# Access Compliance Report

## Public Rights-of-Way

### (Curb Ramps)

Intersection ID: 31208	Main Street: CLACKWYCK_LN	Cross Street: GOODLOE_DR	Location: E
ADA ID: 96FD19C51B69	Ramp Type: Perp	Initial Pass/Fail: Fail	Overall Compliance: No
Severity Score: 1.25			
Codes/Mitigation Info/Possible Solution		Field Measurements/Component Compliance

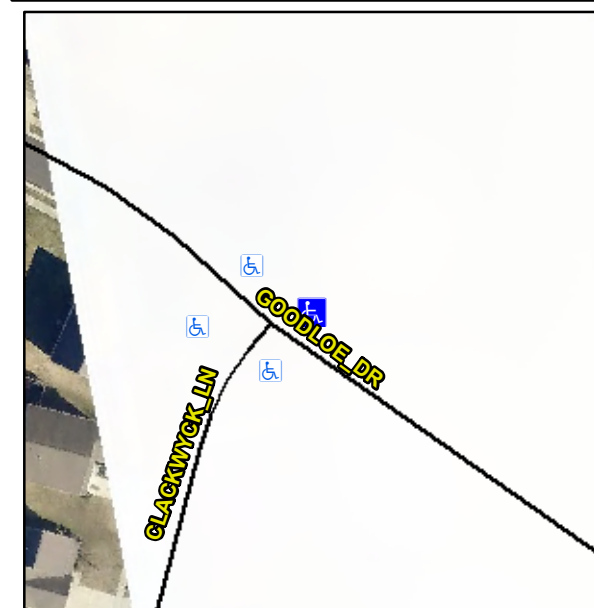
**Not Found, R304.5.3**

Compliance	Description	Data	Compliance	Description	Data
N/A	Ramp Length (in)	46.0	Yes	Ramp Slope (%)	5.0
Yes	Ramp Width (in)	108.0	No	Ramp XSlope (%)	3.8
N/A	Flare Type LT	N/A	N/A	Flare Type RT	N/A
N/A	Flare Slope LT (%)	N/A	N/A	Flare Slope RT (%)	N/A
N/A	Flare Traversable LT?	N/A	N/A	Flare Traversable RT?	N/A
N/A	Landing Length (in)	N/A	N/A	DWS Provided?	N/A
N/A	Landing Width (in)	N/A	N/A	DWS Contrast?	N/A
N/A	Landing Slope (%)	N/A	N/A	DWS Length (in)	N/A
N/A	Landing X Slope (%)	N/A	N/A	DWS Full Width?	N/A
N/A	Landing Curb? (Y/N)	N/A	N/A	DWS Offset (in)	N/A
N/A	Shared Landing?	N/A			
N/A	Gutter Ponding?	N/A	N/A	Gutter Slope (%)	N/A
N/A	Gutter Lip Ht (in)	N/A	N/A	Gutter X Slope (%)	N/A
N/A	Painted X Walk1?	No	N/A	Painted X Walk2?	N/A
	X Walk 1 Direction	To SW		X Walk 2 Direction	N/A
N/A	X Walk 1 Width (in)	N/A	N/A	X Walk 2 Width (in)	N/A
	X Walk 1 Slope (%)	1.3		X Walk 2 Slope (%)	N/A
	X Walk 1 X Slope (%)	2.7		X Walk 2 X Slope (%)	N/A

**Remove & Replace Entire Ramp.**
